COMBI MW ovens - Condensation inside door during cooking function

599 856 511 Rev.00

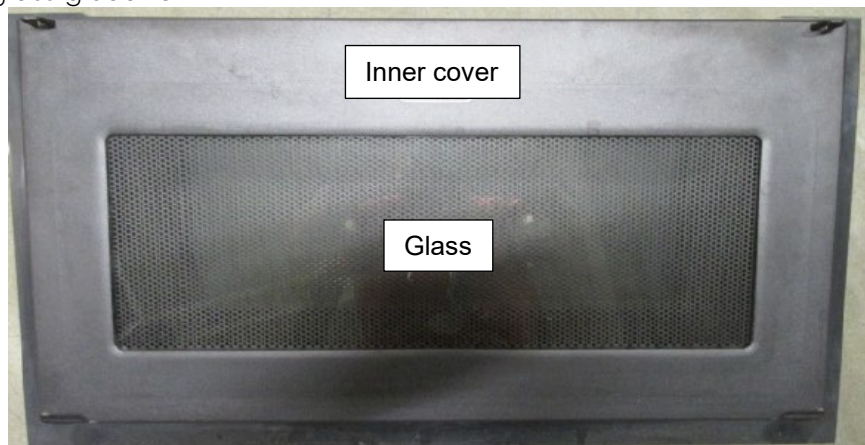
During usage of combi oven, condensation is appearing inside oven door (between the glasses).

The main reason for this kind of failure is lack of tightness between the door inner cover and small inside glass glued to it:

The solution is to replace full inner cover by new spare part number with improved adhesion between plastic cover and glass: **561626486**

Corrective action implemented (improved adhesion between cover and glass) from serial number: 106 XXXXX.
